Yucca Mountain Draft EIS Concerns

Presentation to the Nuclear
Regulatory Commission
January 20, 2000

Clark County Nuclear Waste
Division

Figure 6-16. Potential routes in Nevada for heavy-haul trucks.

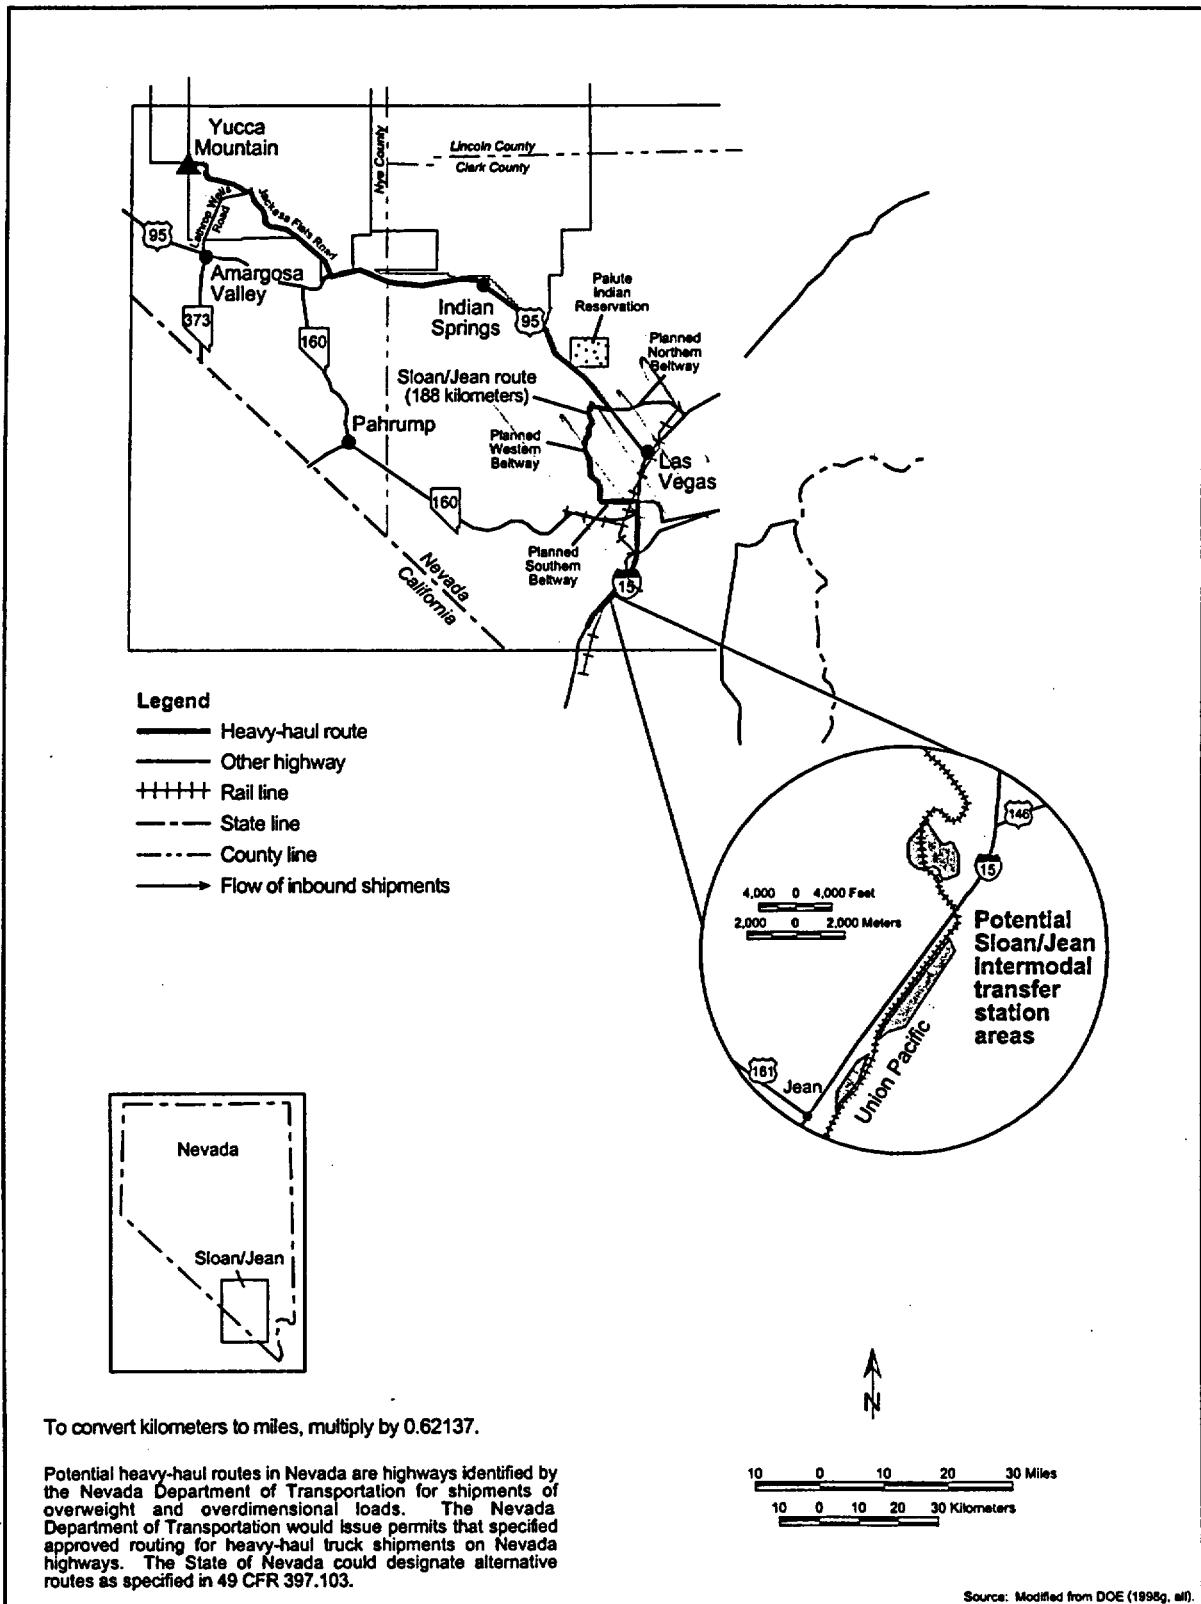
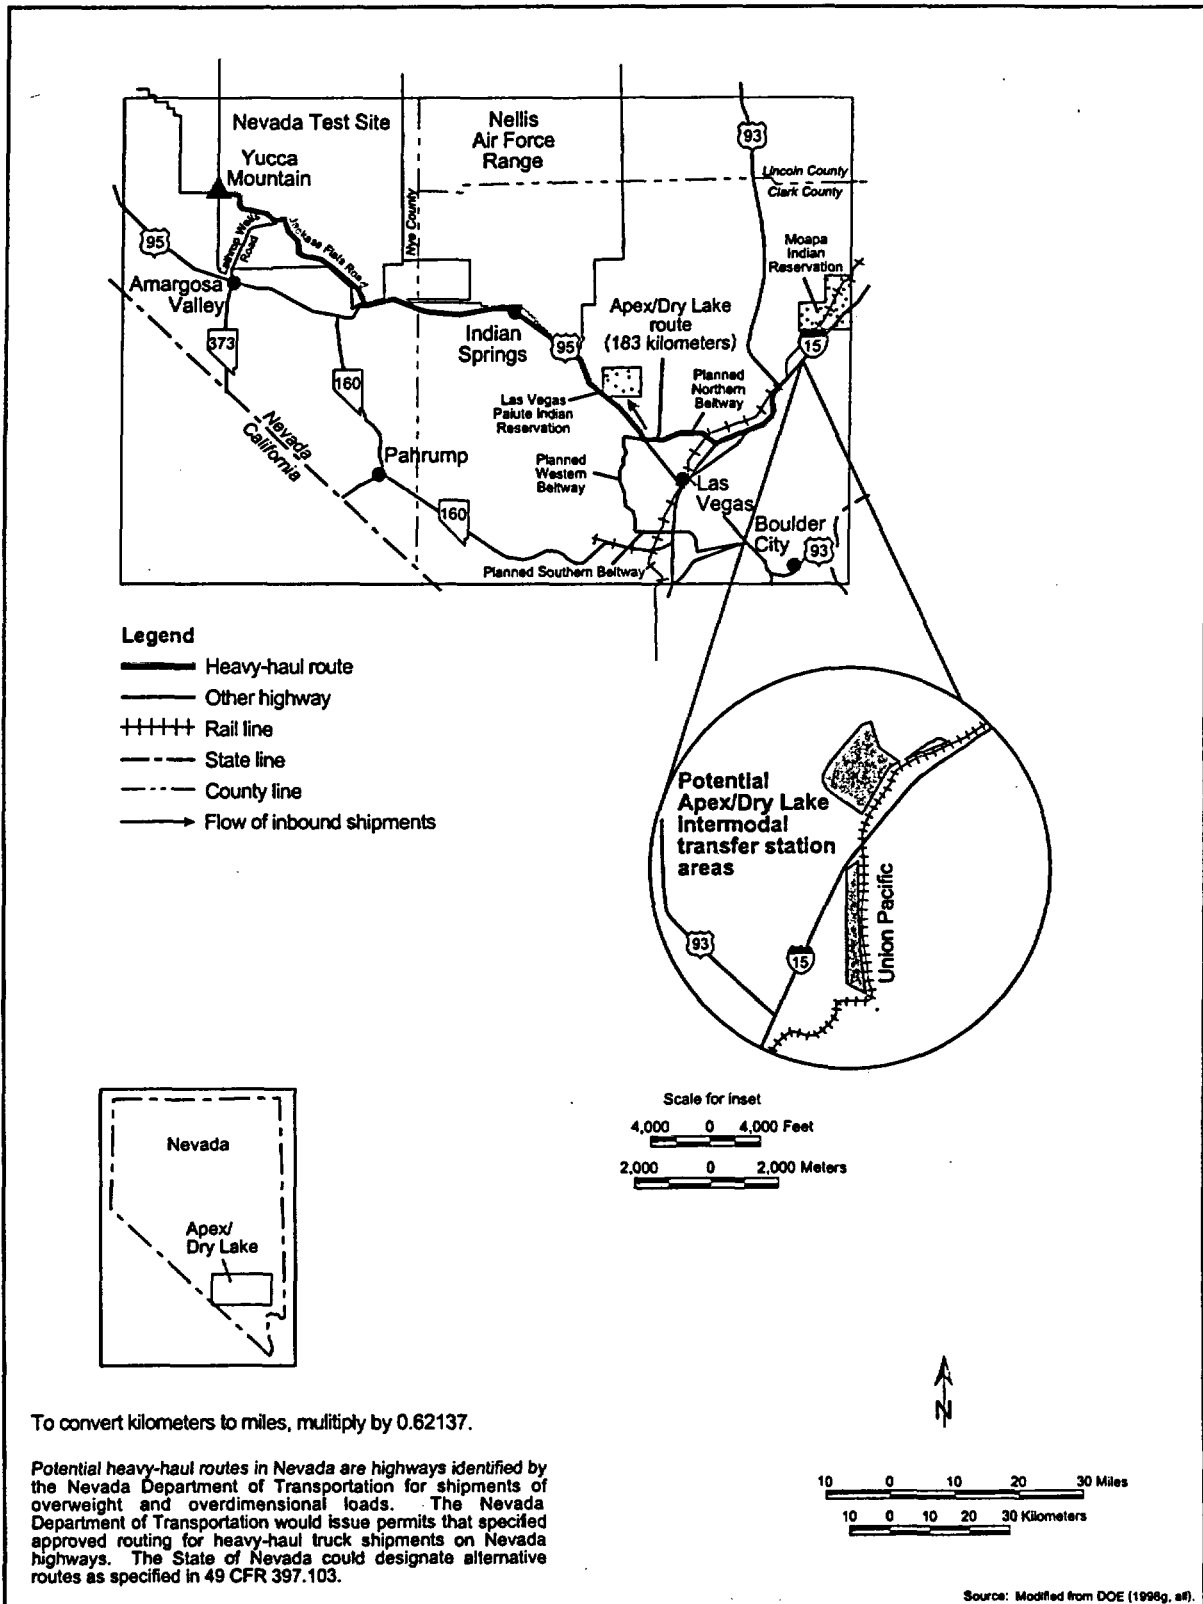
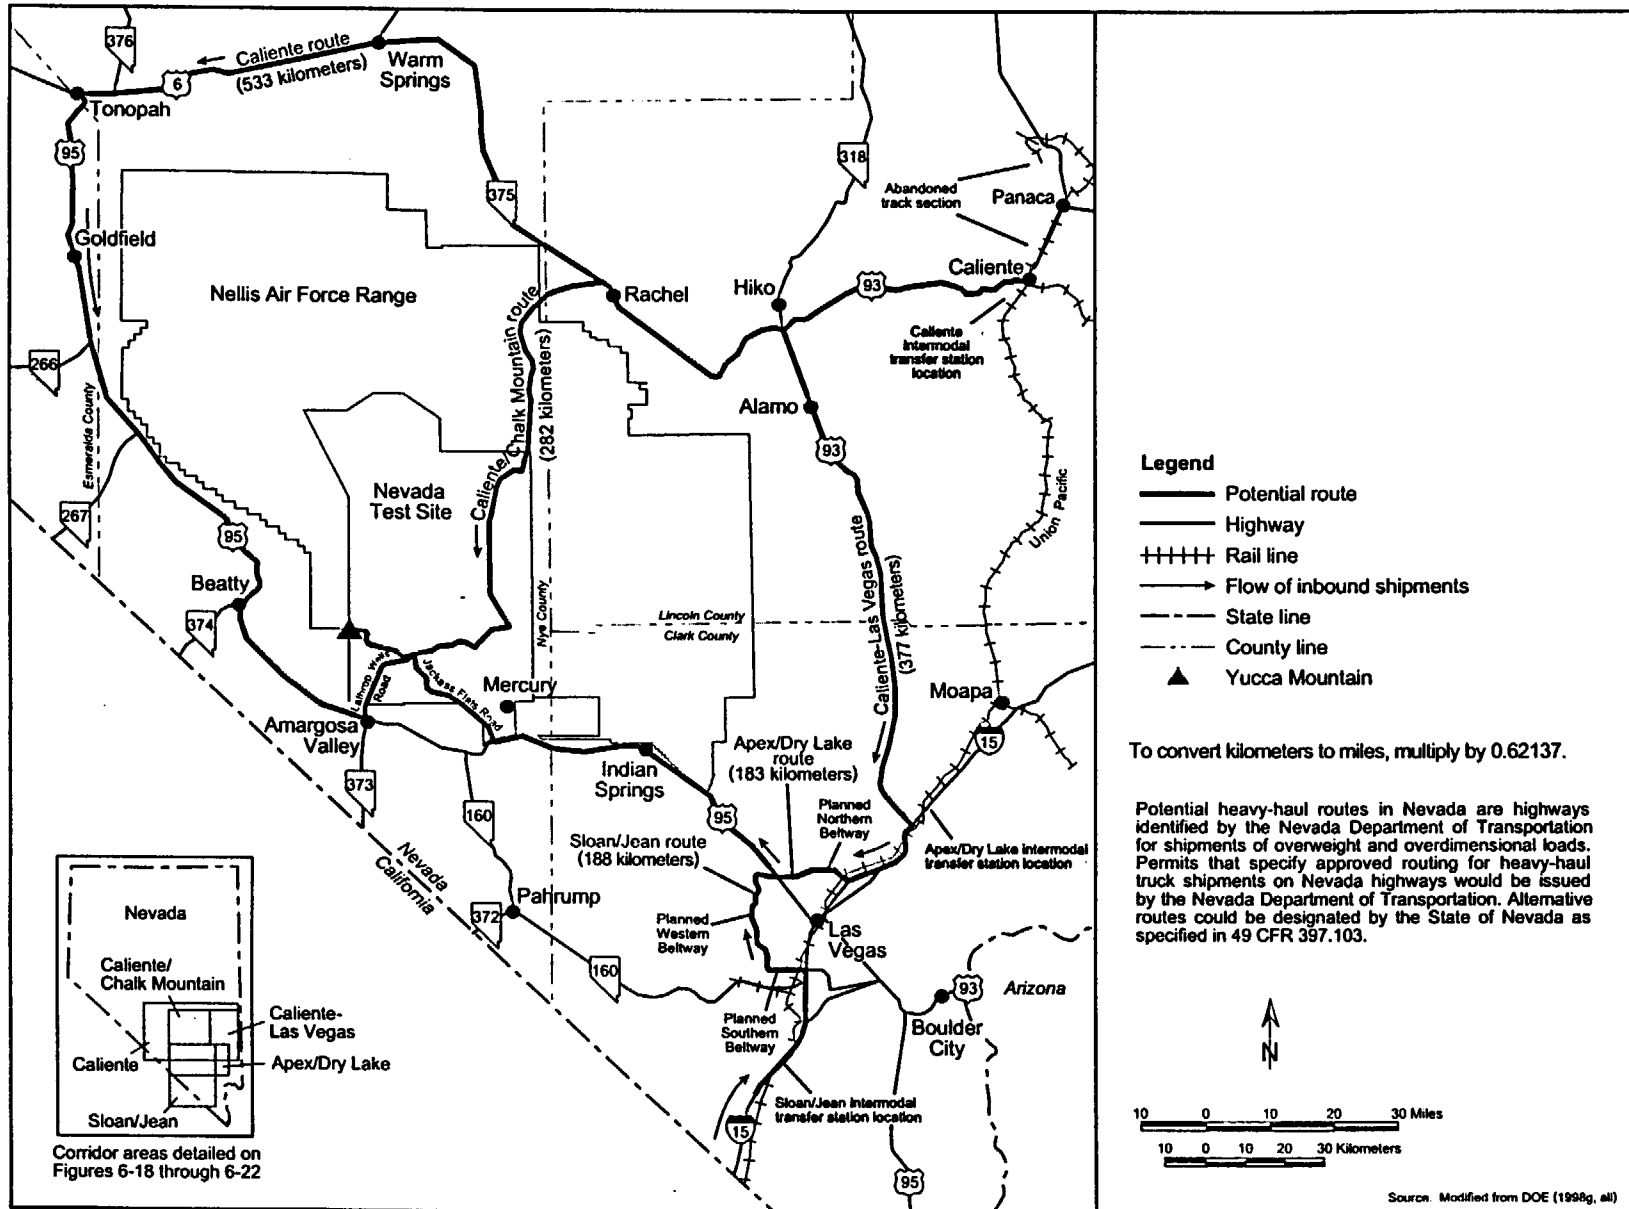
- ◆ Most disruptive of the options
- ◆ Dramatically understated costs could mislead Congress
